Report on a Publicly Notified Resource Consent Application

(Section 42A)

Application Reference:	RMA/2020/702
Applicant:	Lumo Digital Limited
Site address:	399 Lincoln Road, Addington
Legal Description:	Pt RS 9 Canterbury Dist and Lot 1 DP 1406
Proposal:	Establish two 29.2m ² digital billboards
Zoning:	Industrial General
Overlays and map notations:	Christchurch International Airport Protection Surfaces Liquefaction Management Area Adjoins Major (Moorhouse Avenue) and Minor (Lincoln Road) Arterial Roads Adjoins Highly Significant Heritage Item (Hagley Park)
Activity status:	Restricted Discretionary
Submissions:	Four in support Seven in opposition One which does not state a position (Three of these submitters have indicated that they wish to be heard and/or potentially make a joint submission at the hearing) A summary of submitters is included as Appendix A
Date of Hearing:	1 December 2020
Recommendation:	Decline subject to conditions

Figure 2-1: Intersection detail with pole numbers (in red circles)

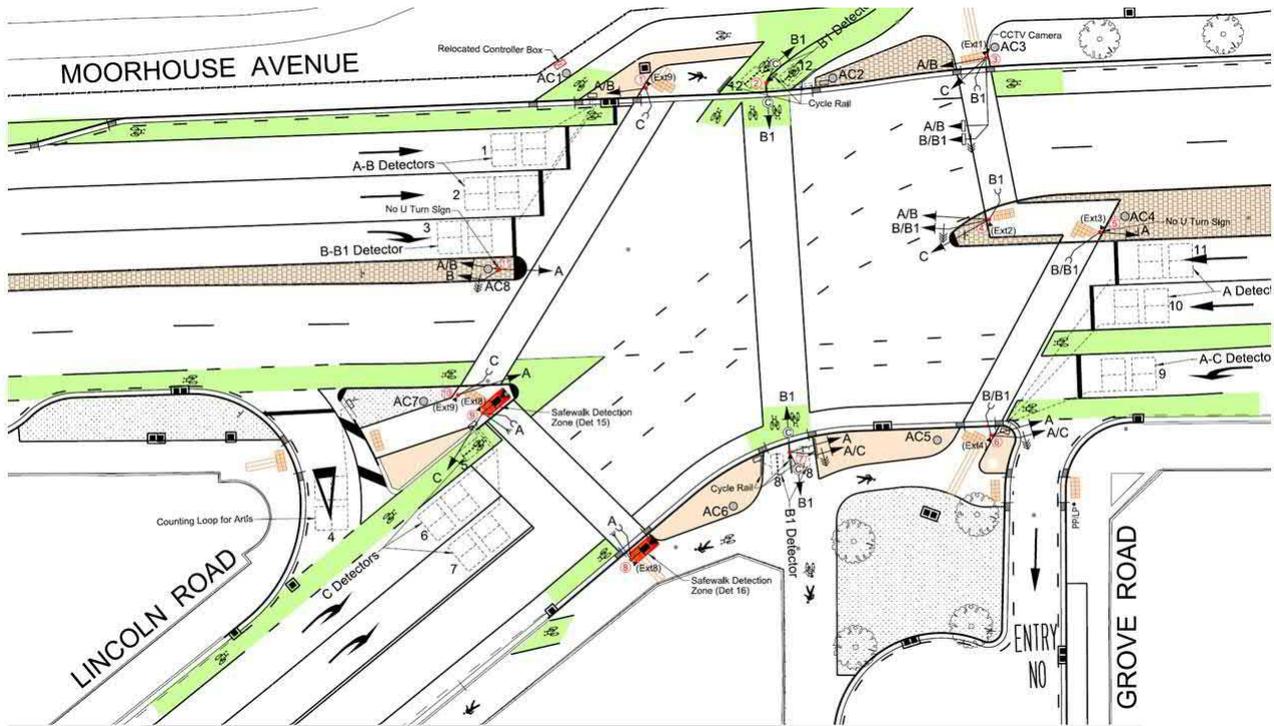
The ITA demonstrates that the east-facing billboard will be aligned horizontally with the primary and advance primary signal faces (i.e. poles 6 and 7 on Figure 2-1 of this review), but that these will be visible above the billboard for an eastbound driver entering and travelling through the decision zone. Note that the ITA focuses on drivers approaching in the left turn lane on the Moorhouse Avenue east approach, but the sightline diagrams show that this also applies to drivers in the central through lane, who may also rely on the signal faces on poles 6 and 7 (whilst also having the option of looking at the dual primary and tertiary poles).

Furthermore, while the ITA notes that not all signals are in the vicinity of the billboard, ViaStrada notes that drivers turning left will focus on the signals to the left side of the road (e.g. poles 6, 7 and 10 in Figure 2-1), which are the ones closest to the east-facing billboard. The left turn is operated independently of the adjacent through movement during the A and C phases (depending on presence of pedestrians on the P3 and P2 crosswalks, see Figure 2-2) so it is necessary for turning drivers to pay particular attention to the arrow signals.

Figure 2-4: Comparison of sightlines for permitted baseline and proposed billboards

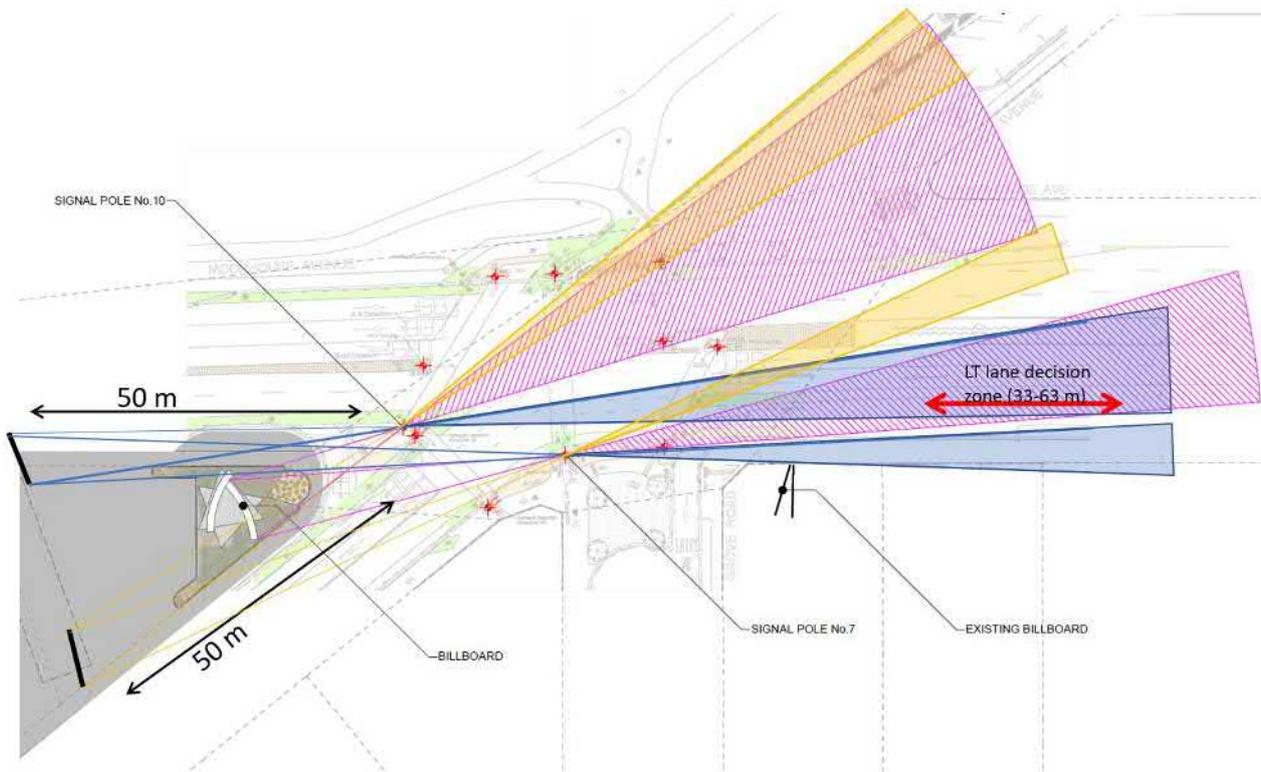
It can be seen from Figure 2-4 that a billboard positioned 50 m back from the intersection on the Moorhouse Avenue side of the property would be in line horizontally with pole 10 for drivers approaching on Moorhouse Avenue east in the decision zone; but the height at which the billboard is mounted would determine at what point along the driver’s trajectory the billboard actually appears in-line with the signal face. More importantly, the signals on poles 7 and 6, which are the critical ones for drivers in the decision zone, would be clear of the billboard, under the permitted baseline scenario (but not the proposal). Figure 2-4 also shows the permitted baseline billboard on the Lincoln Road side of the property would not be in line with any of the relevant signals.

Above: View from the east showing cumulative impact of two billboards (newly established 18m² billboard at 26 Moorhouse Avenue is omitted)

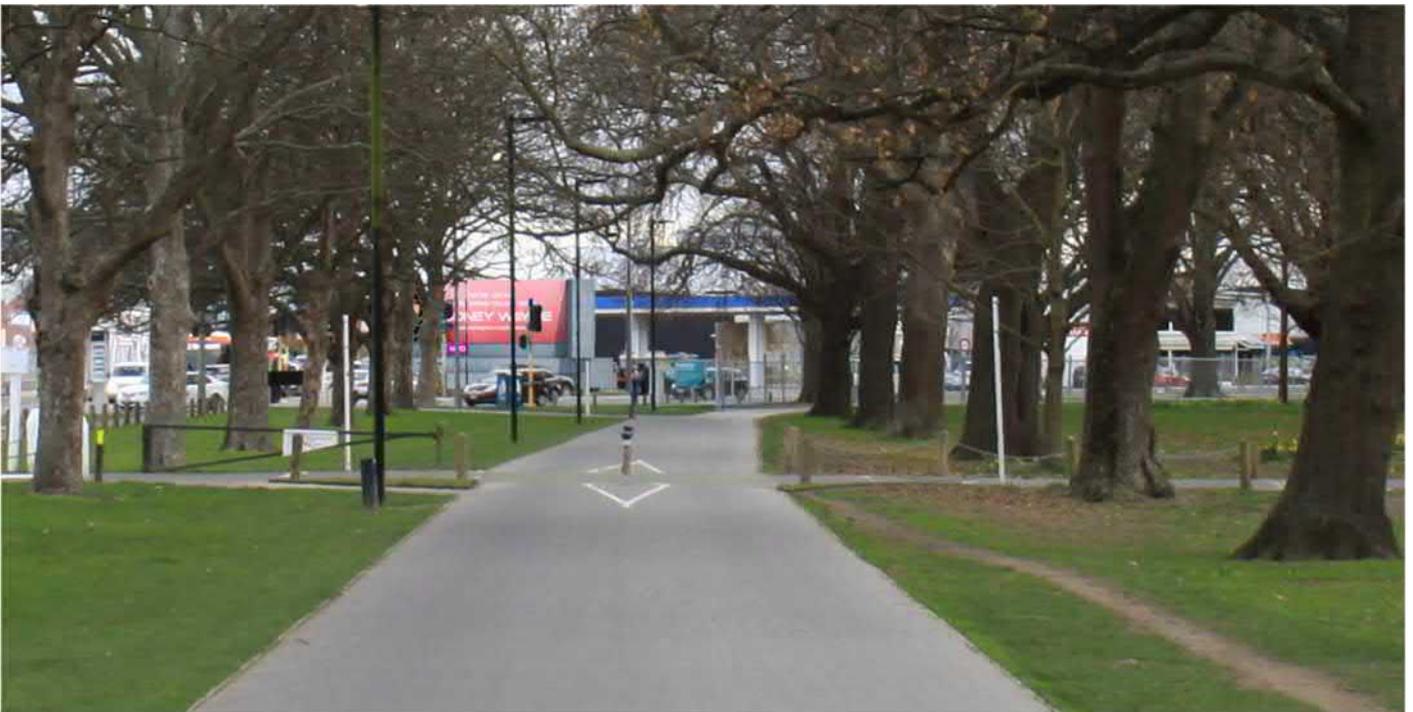
- **Viewed from the east on Moorhouse Avenue,** the effects would be higher, because the sign would be more prominent than the permitted scenario. I consider that it would increase the scale of effects to moderate from this location (between 100m and 200m distance where two signs will be highly visible, with a third in the background), particularly from the footpath where they will be closely aligned in lines of sight. The newly-established permitted billboard at 26 Moorhouse Avenue adds to the perception of clutter and distraction, and underlines that in this environment there is limited capacity for additional signage above the minimum permitted scenario.

700m – St Asaph Street

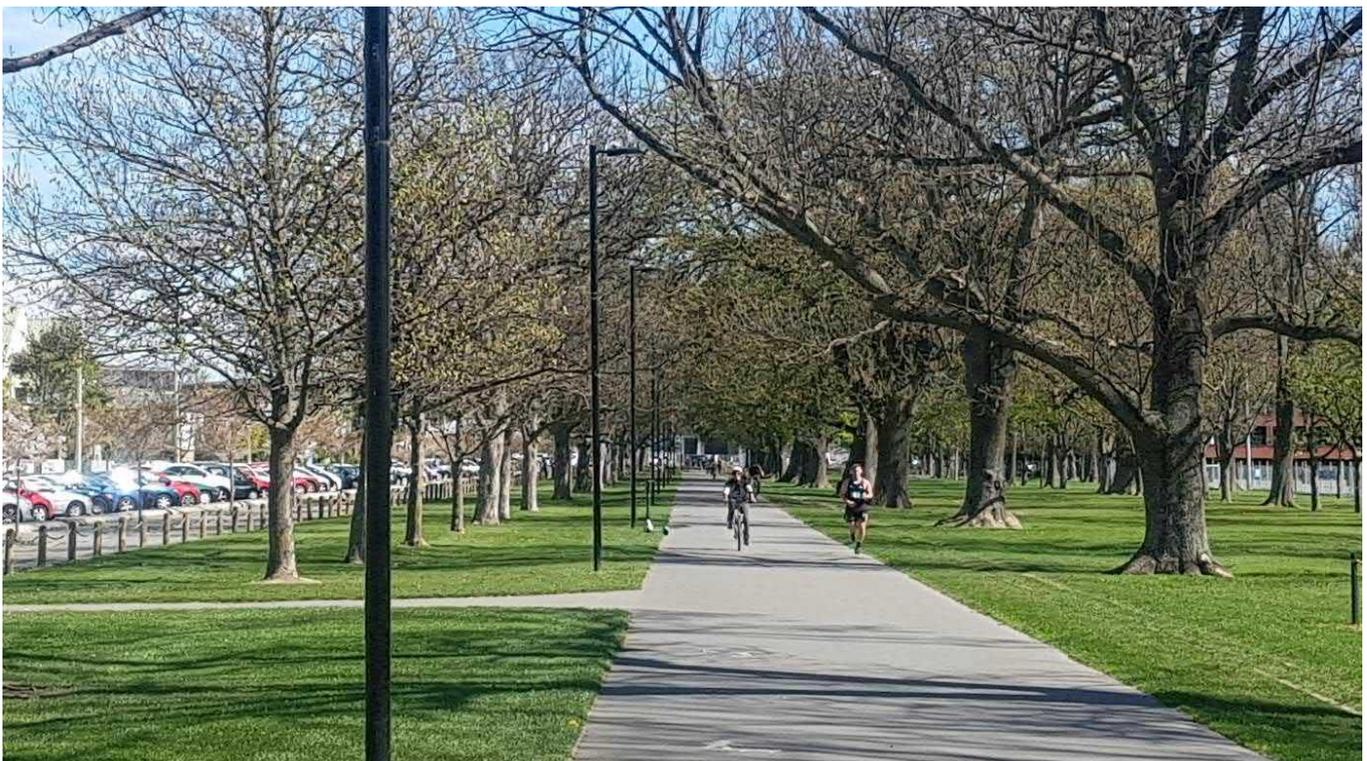
Detail – The sign is fettered by the light poles

The surrounding environment is high quality park, with views funnelled through the trees. The land use adjacent to the park is mixed and there is some through traffic on Hagley Avenue. The environment is high quality, the extent of change is low and the impact will be negligible as a result.

300m – Opposite Hagley Mews

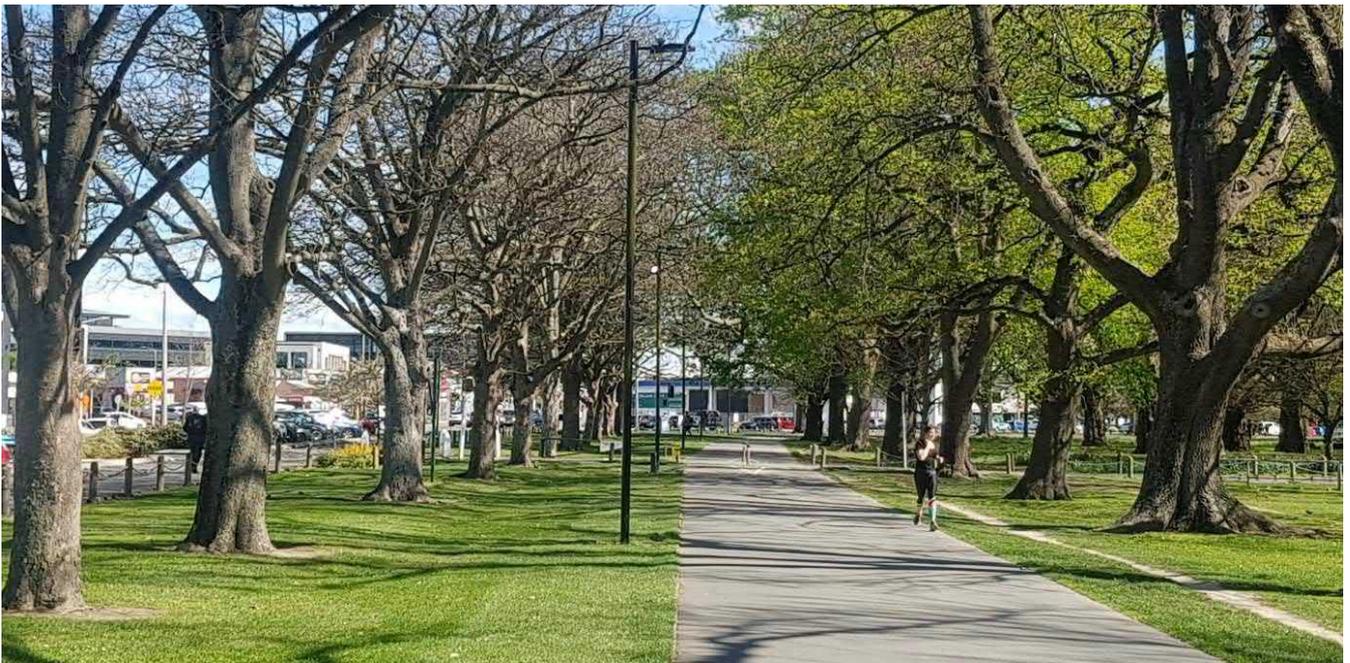
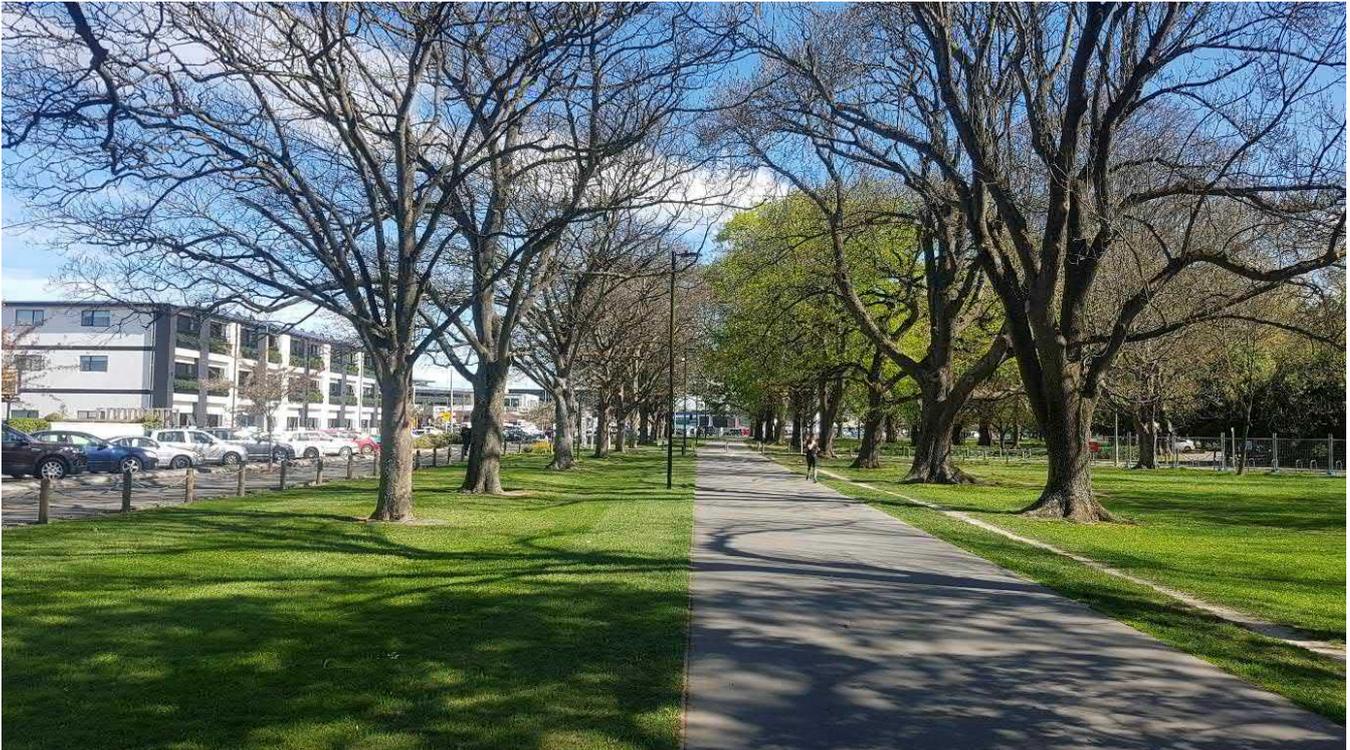
The surrounding environment is high quality park, with views funnelled through the trees. The adjacent land use is residential and there is little traffic on Hagley Avenue and minimal traffic noise. The environment is very high quality.

A static billboard would be visible but not prominent and the extent of change would be low.

Digital transition will be noticable but the impact will be partly absorbed by the surroundings due to distance. The billboard would not be effectively fettered by the poles at this distance. The extent of change for a digital billboard would be medium and the impact will be low-moderate (the sign is uncharacteristic but not prominent).

In low light conditions, the sign will be visible through the poles, which will draw the attention in combination with transitions. In these circumstances, a standard luminance billboard would have a moderate impact (the sign is uncharacteristic but would not amount to a major modification that materially changed the character).

150m (adjacent Netball Courts building crossover)

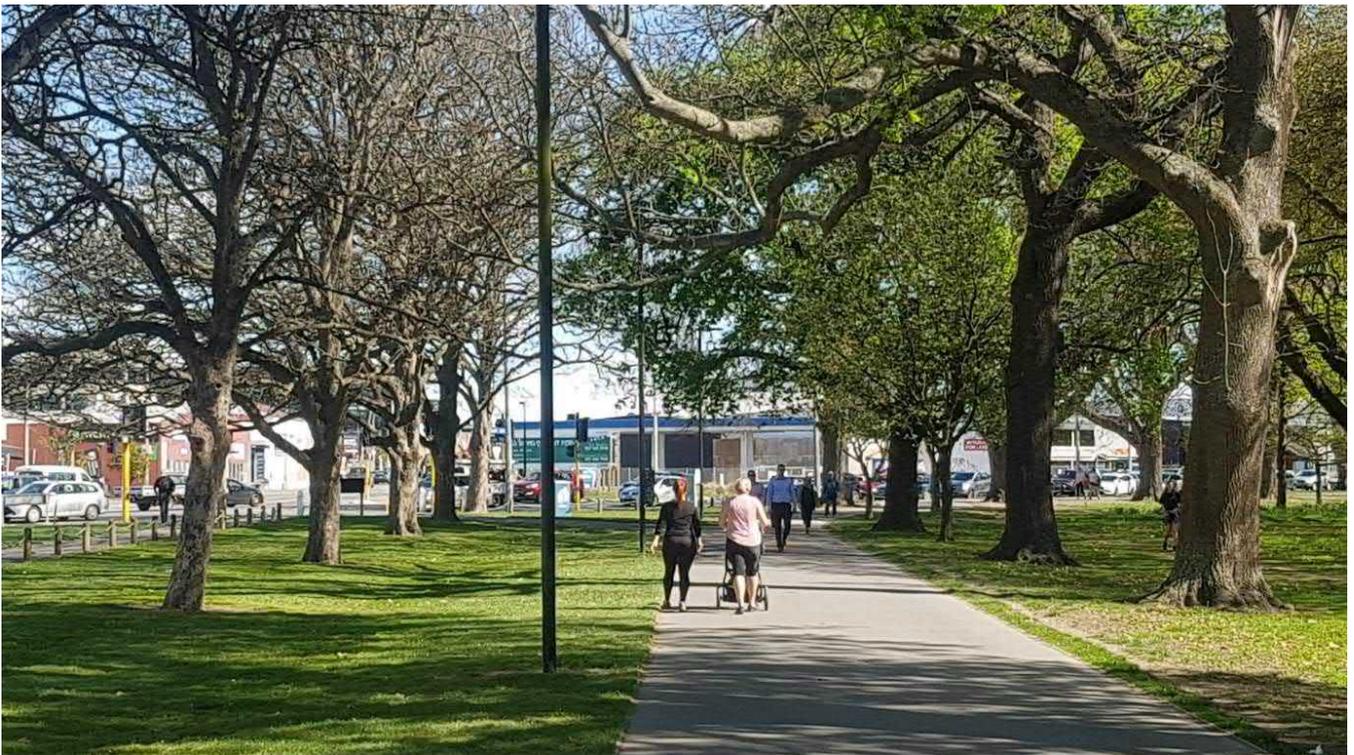
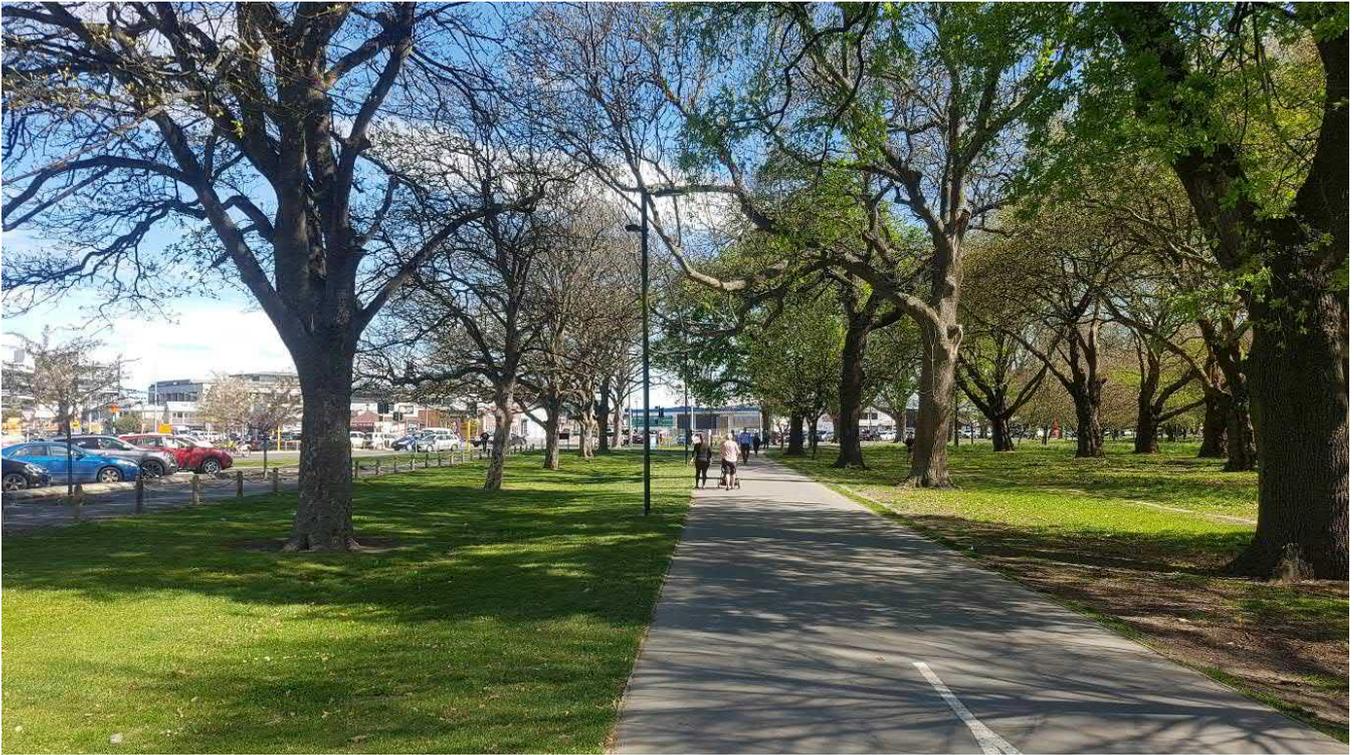
Detail – the sign is clearly visible and prominent.

The extent of change for a static billboard would be medium, with a moderate impact.

The regular changes of a digital billboard seen centrally will call attention to the board in the view corridor, in which the board is prominent. This would distract from the park surroundings which are the defining feature of the environment. For this reason, a digital billboard is assessed as being a major modification to a key feature of the

environment, which is uncharacteristic and would amount to a material change in the character. The impact of a digital billboard is high.
